Item 6.**Development Application 16-18 Meagher Street, Chippendale - D/2022/274**

File No.: D/2022/274

Summary

Figure 20: Southern elevation showing the 9m height control and existing roof form dashed

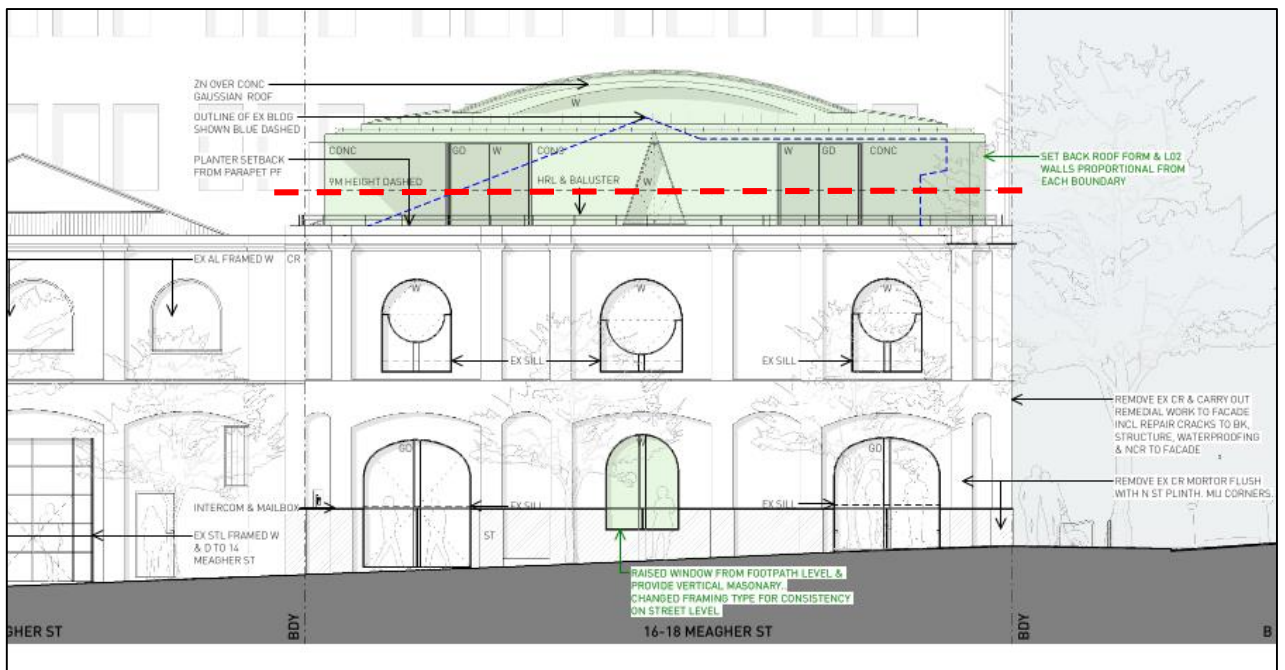
- 46. The site is subject to a maximum height control of 9m.
- 47. The existing building has a maximum height of 10.855m. The proposed development includes the demolition of the existing roof and level 2, and construction of a new third storey and vaulted roof that exceed the height control, with a maximum height of 12.4m above existing ground level, resulting in a variation of 3.4m or 37.7% from the development standard.

51. The applicant's written request has adequately addressed Clause 4.6(3) in that compliance with the building height development standard is unreasonable and unnecessary in the circumstances of this case, and that there are sufficient environmental planning grounds to justify contravening the standard.
- (a) The request demonstrates the objectives of the development standard are achieved notwithstanding non-compliance with the standard; and

Figure 23: Context drawings indicating height of surrounding buildings

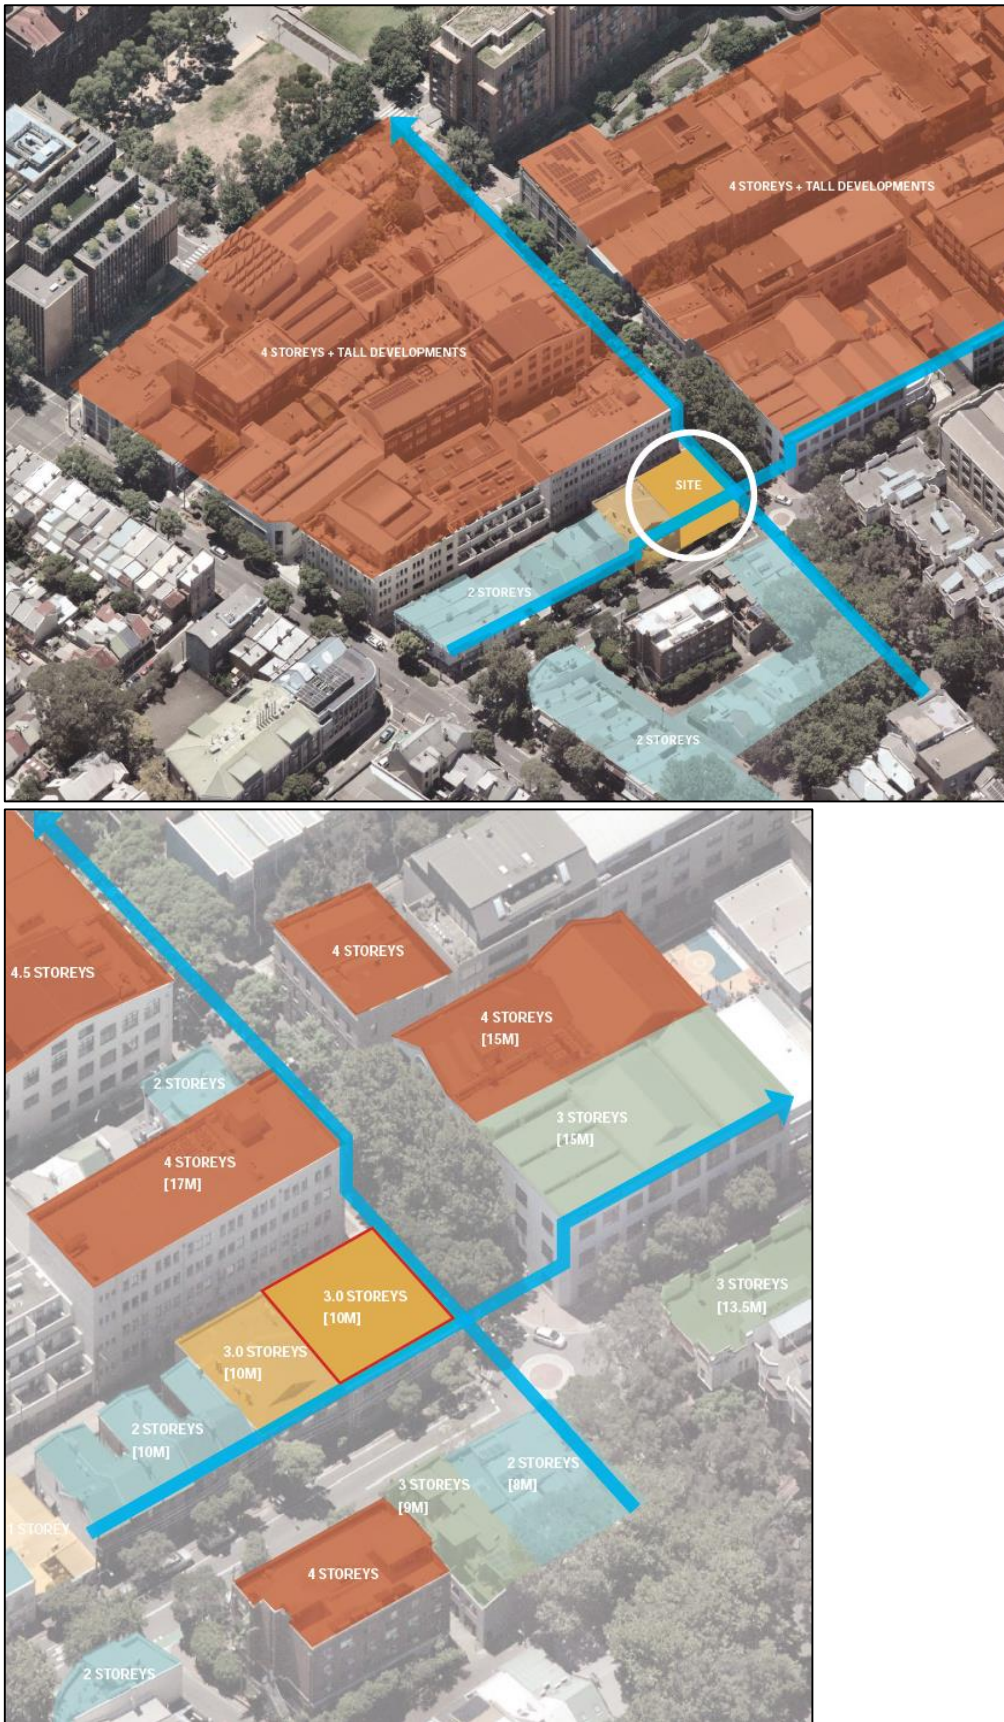
55. The site is subject to a 9m height control under Cl 4.3 of the Sydney LEP 2012, and a two storey height control under Section 4.2.1 of the Sydney DCP 2012. The proposal includes level 2 additions and a new vaulted roof form which have a maximum height of 12.4m and facilitate a third storey. The objective of Section 4.2.1 of the DCP is "(a) *Ensure the height in storeys and street frontage height in storeys reinforces the existing or future neighbourhood character*".
56. The site is not subject to a street frontage height control.
57. An analysis of the surrounding built form demonstrates that the site is within an established mixed-use zone, and nearby buildings generally range from two storey terraces to the south and east, to a larger three and four storey buildings to the south, east and north. This is illustrated in the below figure.

58. It is noted that the surrounding two storey buildings are generally residential terraces houses, and the majority of the surrounding commercial and mixed-use buildings range from three to four storeys in height. Of particular note is the three storey commercial office building directly to the east at 20-40 Meagher St, and the four storey educational building at 53-55 Balfour St directly to the north.
59. It is also noted that the existing building is three storeys, although the existing third storey is recessed and largely contained within the pitched roof, and has limited visibility from the public domain. The proposed additions and new roof form to level 2 will result in a third storey that is more visually prominent as demonstrated in the below perspectives.

Figure 29: View from the sun at 9am mid-winter

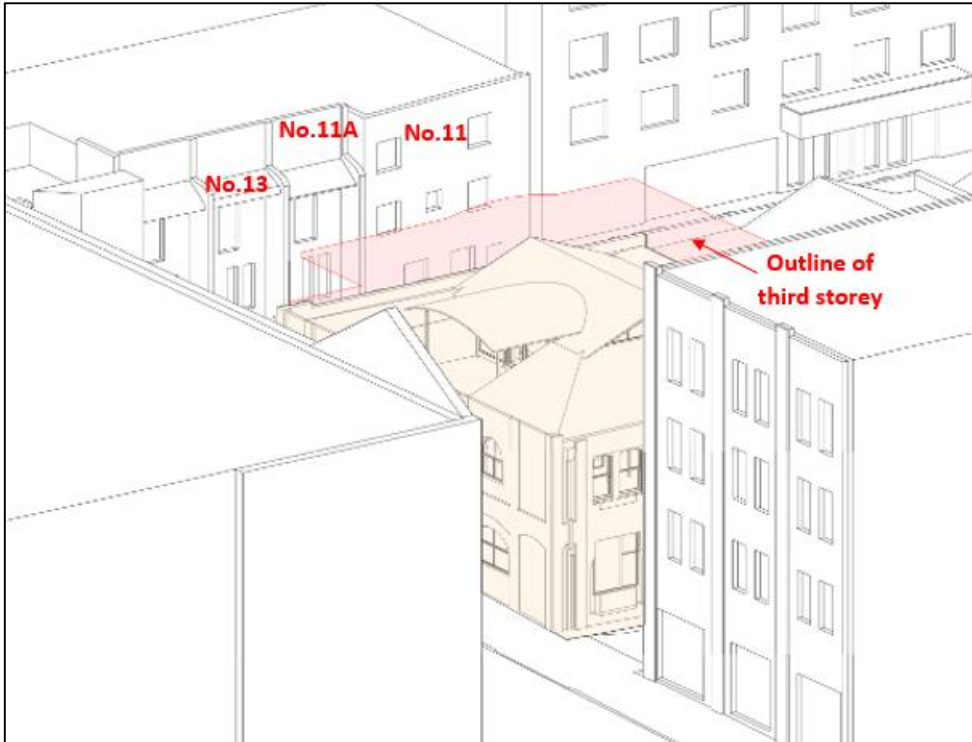
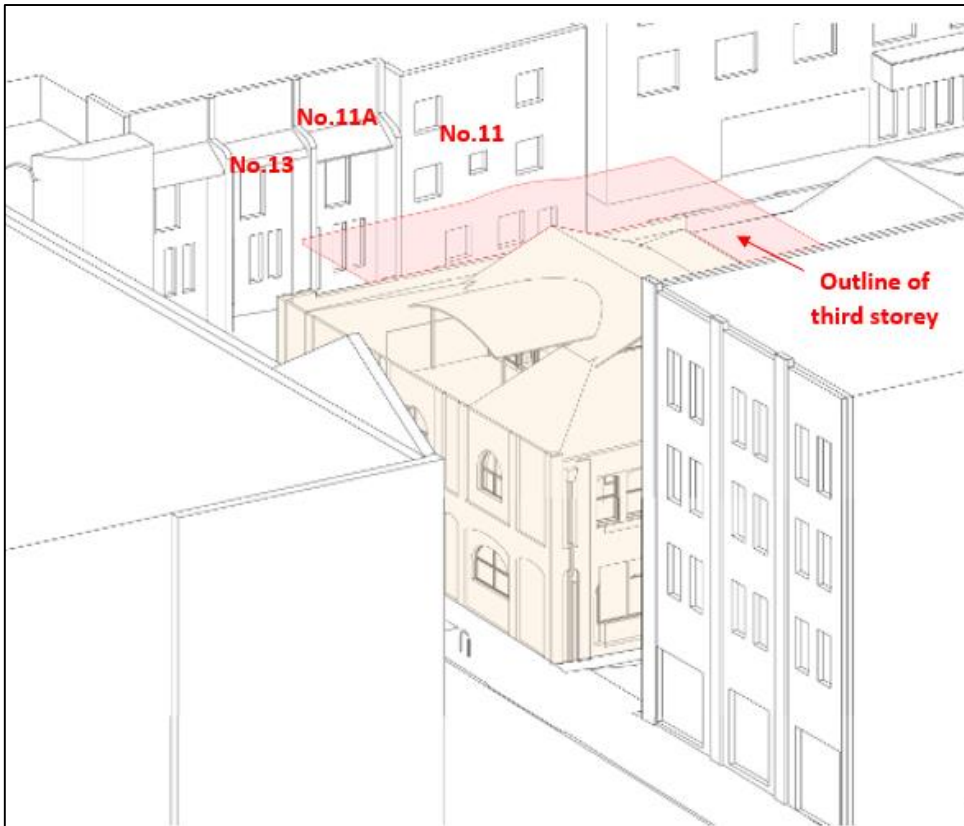
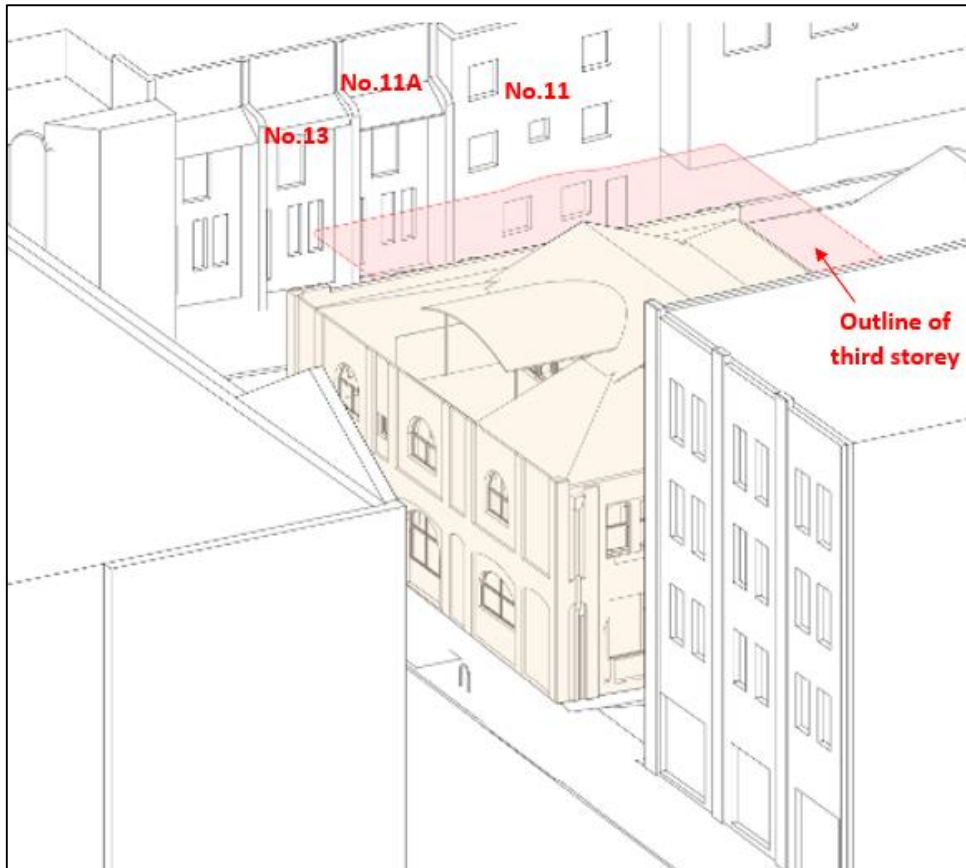
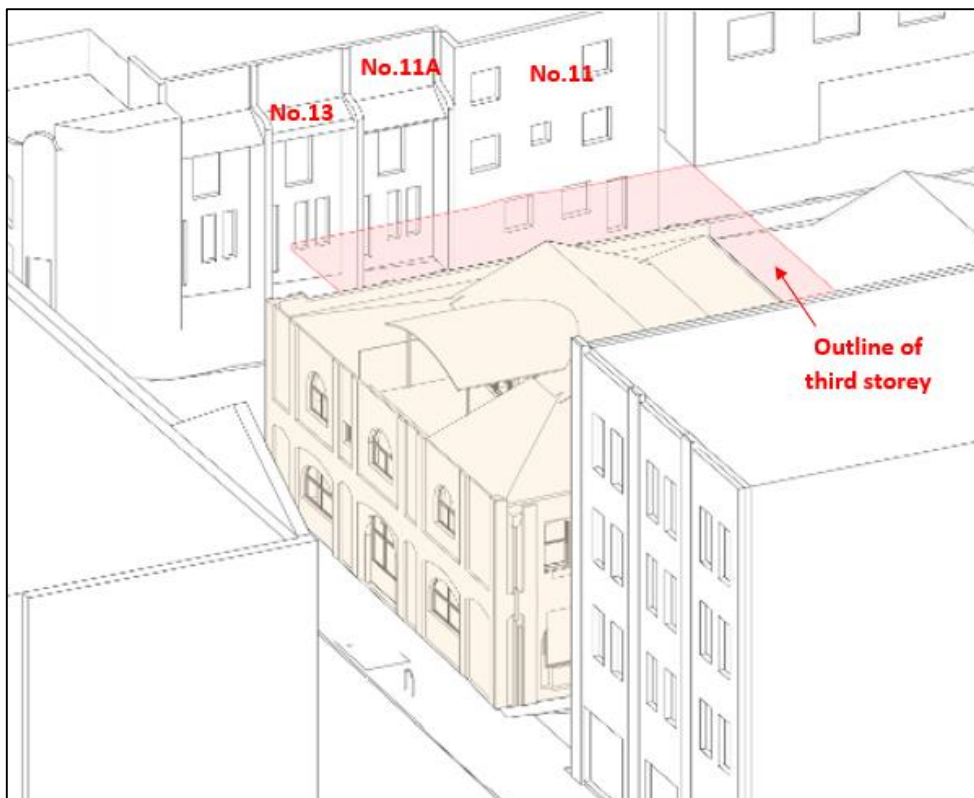
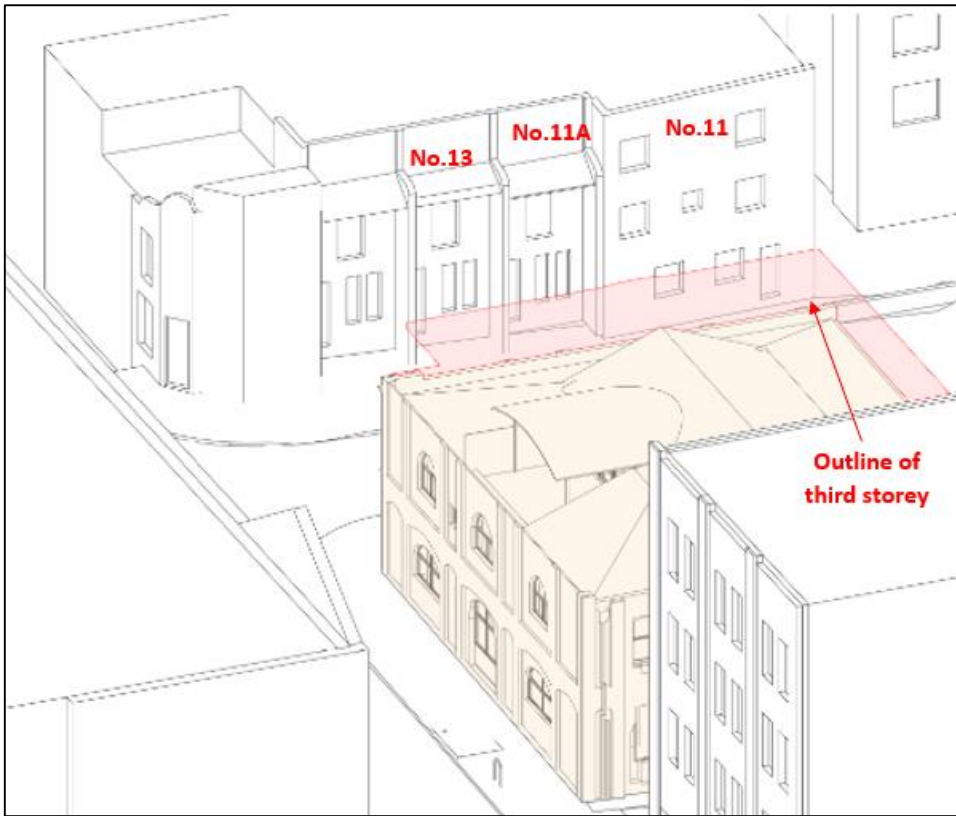
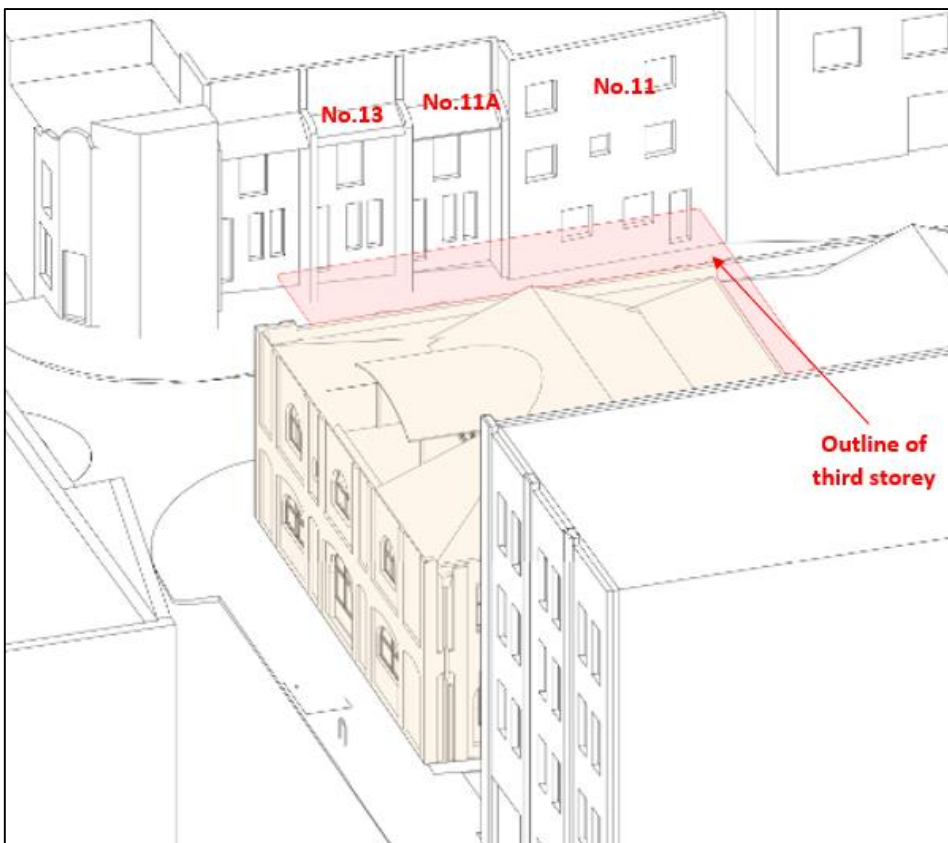
70. The submitted shadow diagrams and view from the sun diagrams indicate that the additional bulk from the third storey additions will create additional overshadowing to the ground floor north facing windows of the residential properties along the southern side of Meagher St at 11-13 Meagher St, from 9am to 10:15am, mid-winter. As demonstrated in the below view from the sun diagrams, the ground floor windows of No.11 will be overshadowed from 9am to 10:15am mid-winter, while the ground floor windows of No.11A will be partially overshadowed from 9am to 9:45am mid-winter, and there will be very minor overshadowing to the ground floor windows of No.13 from 9:30am to 9:45am mid-winter.

71. The submitted view from the sun diagrams demonstrate that although the proposal overshadows the ground floor windows of No.11, 11A and 13 in the morning during mid-winter, these properties maintain solar access to the windows of habitable rooms for at least 2hrs, from 10:30am to 1pm mid-winter, in accordance with the controls.
72. The proposal therefore does not result in any unreasonable overshadowing impacts to neighbouring residential properties.

Figure 35: Separation distances from the subject building to the southern side of Meagher St

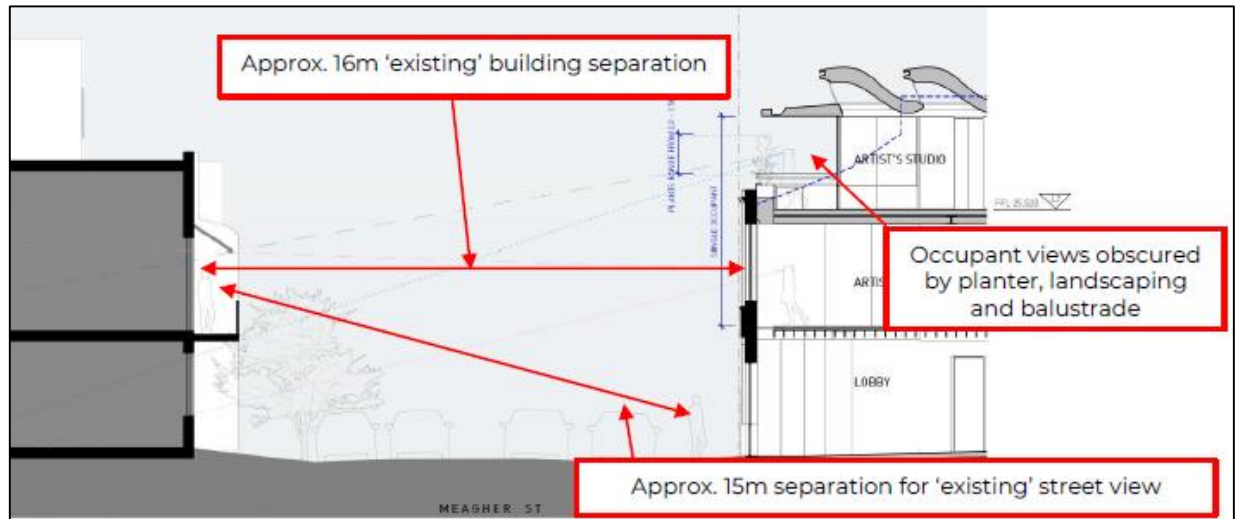
75. The proposed art studio use of the first and second floor is not considered to be a significant intensification from the previously approved office use. The lowering of the first floor window sill heights by between 460mm to 550mm, is not considered to result in any unreasonable additional overlooking impacts to the southern terraces given that they are located on the opposite side of Meagher St, with an approximate 16m separation distance as demonstrated in the below figure.

76. An approximate 16m separation distance is also achieved to the commercial buildings on the eastern side of Balfour St, and an approximate 8m separation distance to the educational establishment on the opposite side of Teggs Lane. Given that the nearest buildings to the east (20-40 Meagher St), and to the north (53-55 Balfour St) are established non-residential buildings, being approved office uses to the east, and educational uses to the north, the overlooking impacts are considered acceptable.

Figure 36: Comparison in design of existing and proposed first floor windows

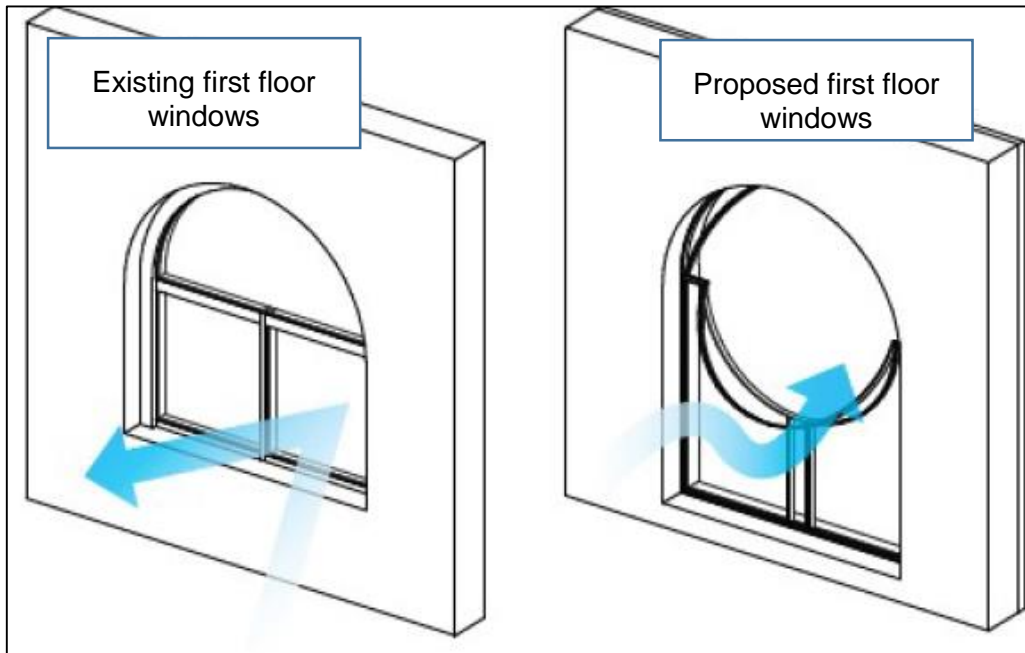
77. In addition, the redesign of the first floor windows and lowering of the sill height will allow greater natural light and ventilation to the first floor and result in improved amenity for future employees and visitors, as demonstrated in the below figure:
